PLANNING NMA-CHANGE LIST		
ID	Proposed Changes to plans that are 'Non Material'	Reason for 'Amendment'
A	Changes to Common stair towards compliance for general access where a clear landing needs to be provided and to accommodate smoke control. Circulation area and internal doorway to stairs rearranged to adapt corridor aisle. Stairs, structurally stacked for construction leading towards the corridor or lobby next to the stair being provided with a smoke vent and a store area provision on ground level. Rearrangement in plan due to the above visible on the Northeast facade. Window openings, adapted to suit mentioned changes/rearrangement.	Compliance towards Building Regulations, Part-K-Protection from falling, collision and impact and Part-B-Fire safety
B	Changes to Communal lifts and stairs towards compliance for firefighting where a firefighting shaft is required as the building is over 18m and to accommodate smoke control and building services. Circulation area internal doorway to stairs and clear landing for lifts rearranged to adapt corridor aisle. Stairs, structurally stacked for construction leading towards a vertical smoke shaft that opens at roof level with rationalised comm

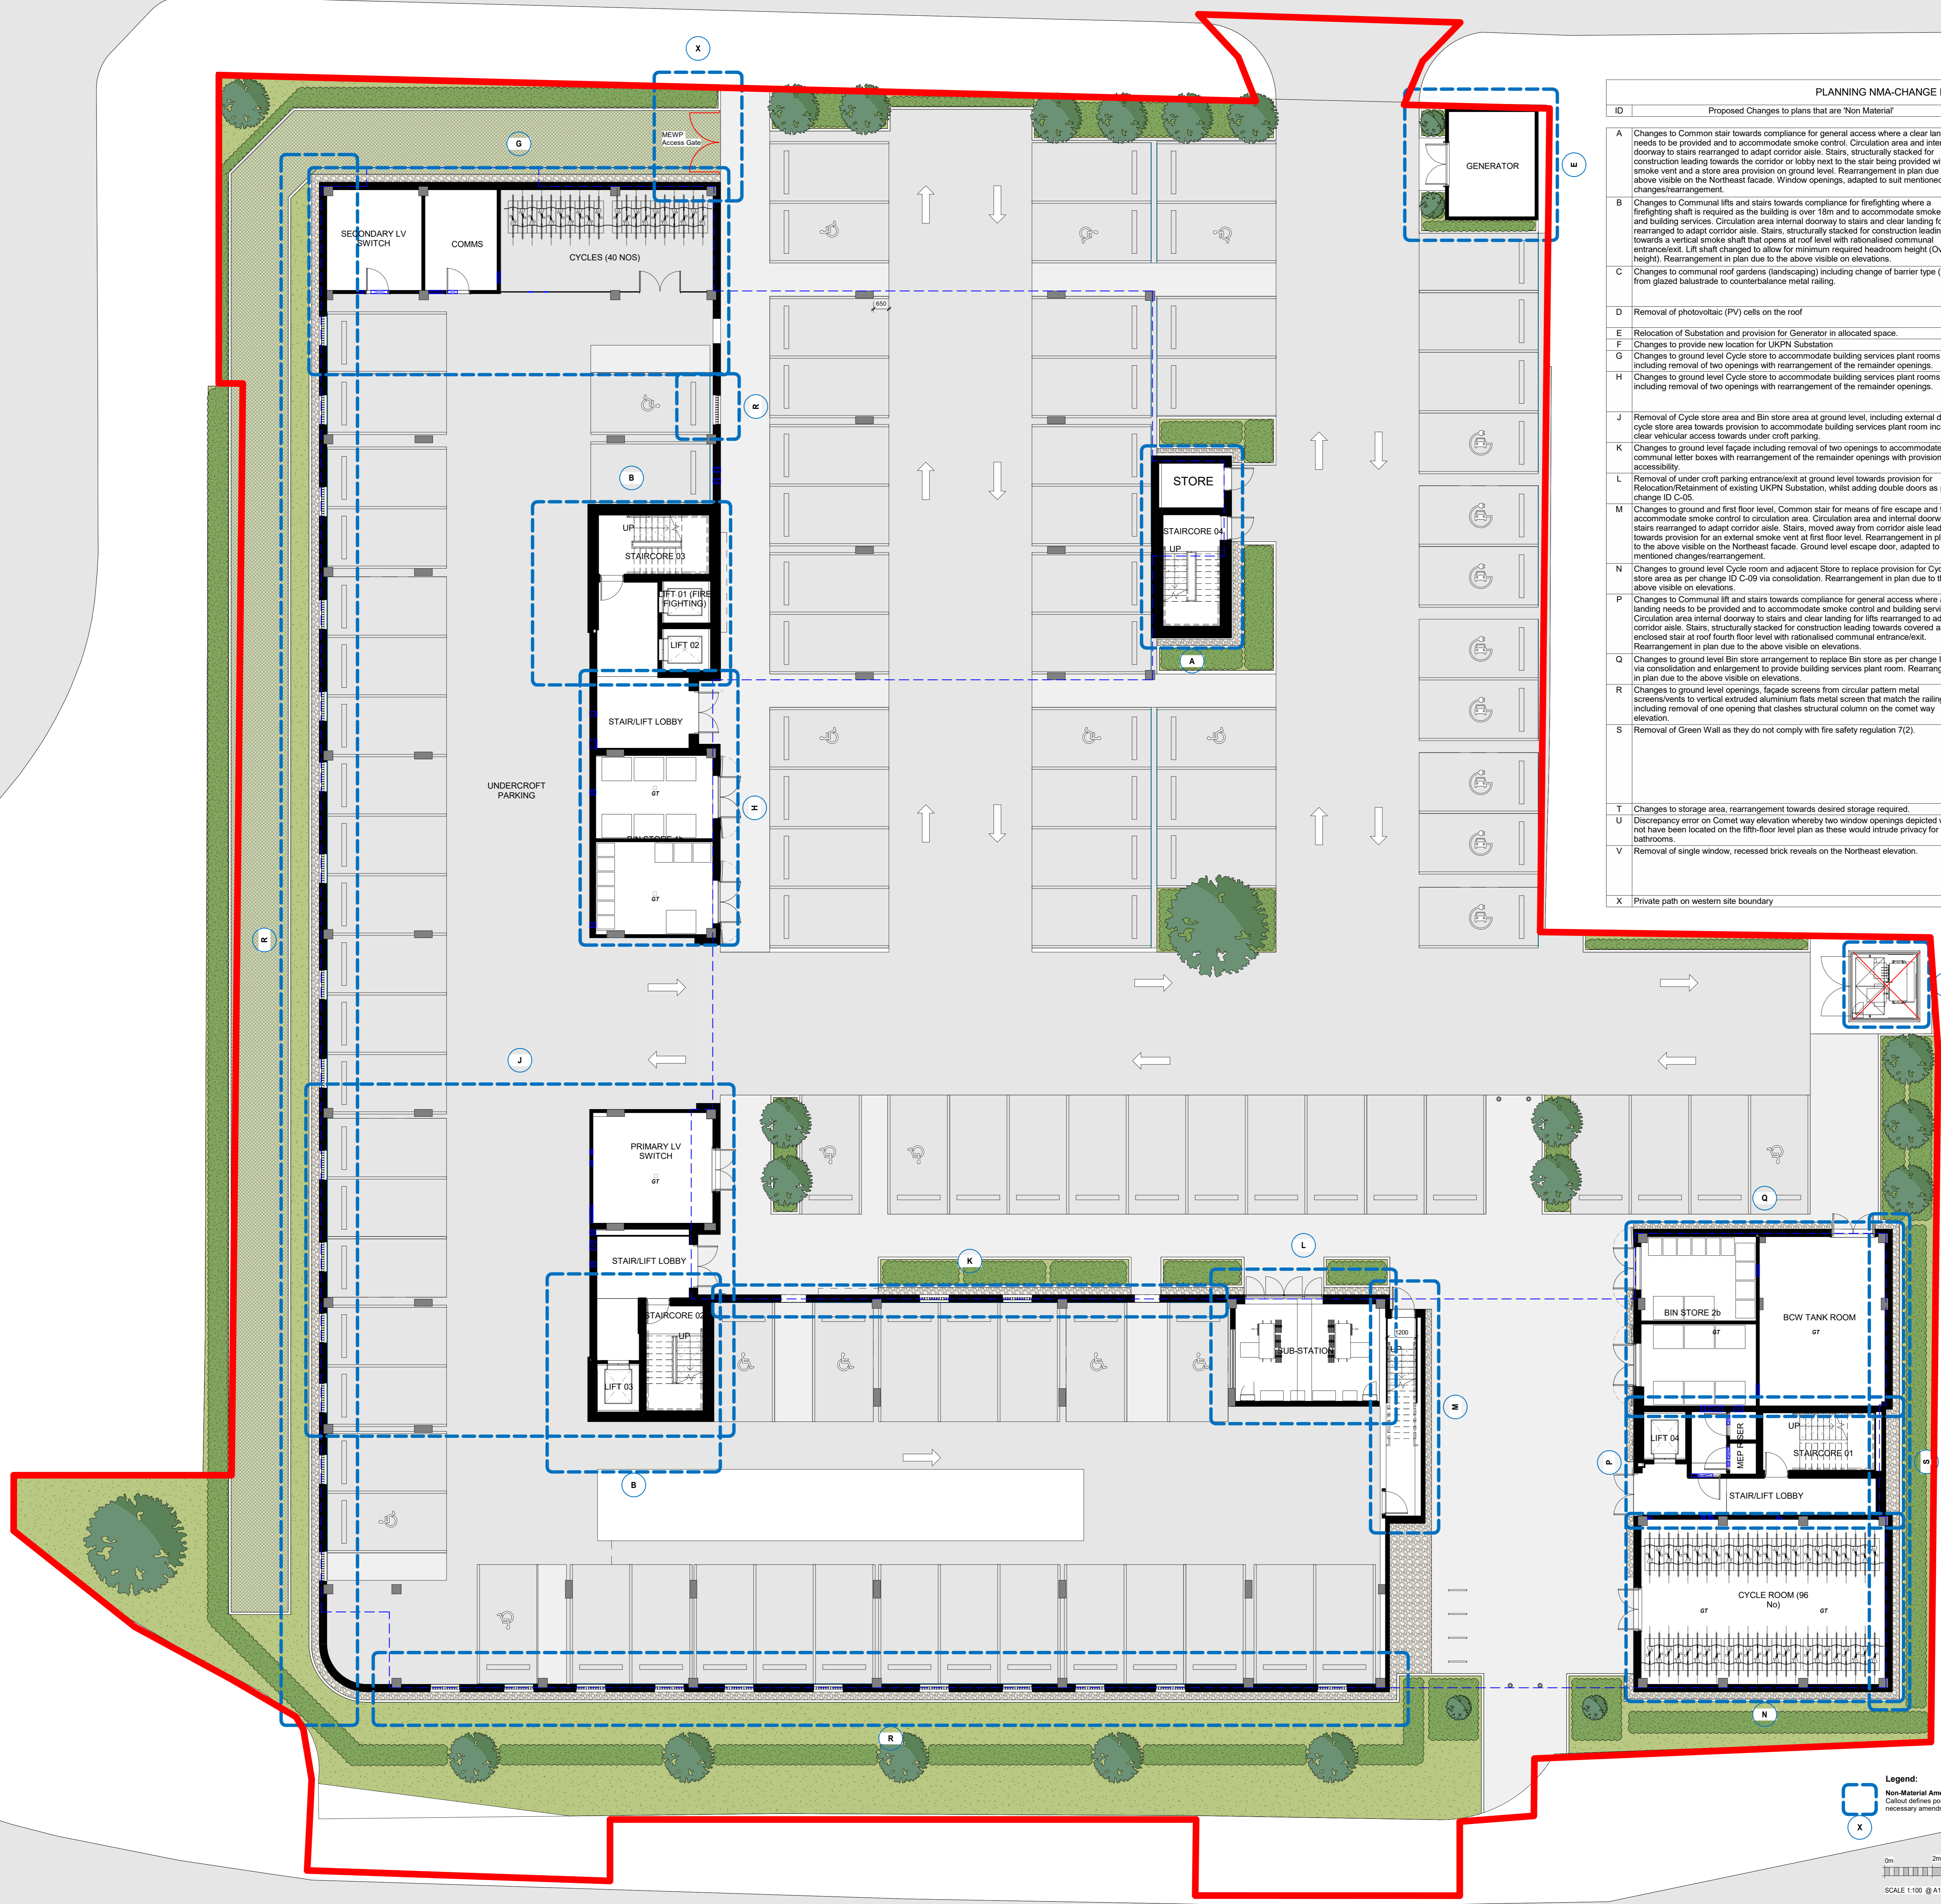
C	Changes to communal roof gardens (landscaping) including change of barrier type (railing) from glazed balustrade to counterbalance metal railing.	To contribute positively towards biodiversity via balance of soft and hard landscaping schemes including provisions for bird and bat boxes, whilst maintaining overall uniformity for railing type.
D	Removal of photovoltaic (PV) cells on the roof	PV was not required as Part L requirement was met using Exhaust Air Heat Pumps.
E	Relocation of Substation and provision for Generator in allocated space.	Provision for separate secluded area for generator
F	Changes to provide new location for UKPN Substation	Provision for future relocation for UKPN Substation
G	Changes to ground level Cycle store to accommodate building services plant rooms including removal of two openings with rearrangement of the remainder openings.	Provision towards Building Services, Secondary LV switch room and Comms room.

H	Changes to ground level Cycle store to accommodate building services plant rooms including removal of two openings with rearrangement of the remainder openings.	Provision towards secure access and splitting into 4 small bin stores to comply with recent updates of having maximum 8 large (1100lrs) receptacles within.
J	Removal of Cycle store area and Bin store area at ground level, including external door in cycle store area towards provision to accommodate building services plant room including clear vehicular access towards undercroft parking.	Provision towards Building Services, Primary LV switch room and vehicular access towards undercroft parking.
K	Changes to ground level facade including removal of two openings to accommodate communal letter boxes with rearrangement of the remainder openings with provision for accessibility.	Provision towards communal letter boxes
L	Removal of undercroft parking entrance/exit at ground level towards provision for Relocation/Retainment of existing UKPN Substation, whilst adding double doors as per change ID C-05.	Provision towards single point of entry/exit for undercroft parking and towards relocation/retainment of existing UKPN Substation mentioned in change ID-E.

M	Changes to ground and first floor level, Common stair for means of fire escape and to accommodate smoke control to circulation area. Circulation area and internal doorway to stairs rearranged to adapt corridor aisle. Stairs, moved away from corridor aisle leading towards provision for an external smoke vent at first floor level. Rearrangement in plan due to the above visible on the Northeast facade. Ground level escape door, adapted to suit mentioned changes/rearrangement.	Compliance towards Building Regulations, Part-B-Fire safety.
N	Changes to ground level Cycle room and adjacent Store to replace provision for Cycle store area as per change ID C-09 via consolidation. Rearrangement in plan due to the above visible on elevations.	Provision towards replacement of removed cycle store mentioned in change ID-J.
P	Changes to Communal lift and stairs towards compliance for general access where a clear landing needs to be provided and to accommodate smoke control and building services. Circulation area internal doorway to stairs and clear landing for lifts rearranged to adapt corridor aisle. Stairs, structurally stacked for construction leading towards covered and enclosed stair at roof fourth floor level with rationalised communal entrance/exit. Rearrangement in plan due to the above visible on elevations.	Compliance towards Building Regulations, Part-K-Protection from falling, collision and impact, Part-B-Fire safety and Provision for stair enclosed/walkway that is directly covered.

Q	Changes to ground level Bin store arrangement to replace Bin store as per change ID C-09 via consolidation and enlargement to provide building services plant room. Rearrangement in plan due to the above visible on elevations.	Provision towards replacement of removed Bin store mentioned in change ID-J and provision for BCW Tank room
R	Changes to ground level openings, facade screens from circular pattern metal screens/vents to vertical extruded aluminium flats metal screen that match the railing type, including removal of one opening that clashes structural column on the corner way elevation.	To maintaining overall architectural uniformity and structural framing.
S	Removal of Green Wall as they do not comply with fire safety regulation 7(2).	Regulation 7(2), requires all residential blocks with top storey heights over 18m to have all materials which become part of an external wall or specified attachment (e.g., balconies) to achieve class A2-s1, d0 or class A1, except for materials which are exempt as per regulation 7(3). Additionally, membranes used as part of external wall construction above ground should achieve a minimum of class B-s3, d0.

T	Changes to storage area, rearrangement towards desired storage required.	Provision towards desired storage required.
U	Discrepancy error on Comet way elevation whereby two window openings depicted would not have been located on the fifth-floor level plan as these would intrude privacy for the bathrooms.	Discrepancy error
V	Removal of single window, recessed brick reveals on the Northeast elevation.	The recessed brick reveals is towards the left of a single pane window for levels 1-4, whilst it changes to a double pane for level 5. To maintain architectural uniformity, we have detailed a constant double pane window for all levels.
X	Private path on western site boundary	For Façade maintenance MEWP access.
